TERMINALS

N-TYPE AND 53-TYPE CABLE TERMINALS

DESCRIPTION AND INSTALLATION

1.001 This addendum supplements Section 631-210-101, Issue 3. Place this pink sheet ahead of Page 1 of the section.

Fig. 13—Locating Strand Mounted Terminal

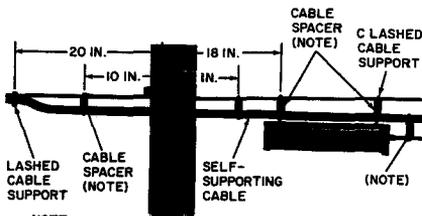
1.002 This addendum is issued to revise placement of cable spacers and lashed cable supports on strand mounted N-type cable terminals.

2.001 On Page 7, Fig. 13 and 14 shall be replaced with revised Fig. 13 and 14 as shown in this addendum.

USE APPROPRIATE SIZE CABLE SPACER TO KEEP CABLES PARALLEL AND AT THE SAME LEVEL OR SLIGHTLY LOWER THAN CLOSURE NOZZLES.

Fig. 14—10- or 16-Pair N-Type Cable Terminal Installed

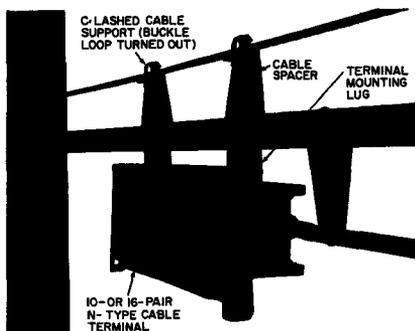
2.002 On Page 7, Fig. 13 and 14 shall be replaced with revised Fig. 13 and 14 as shown in this addendum.
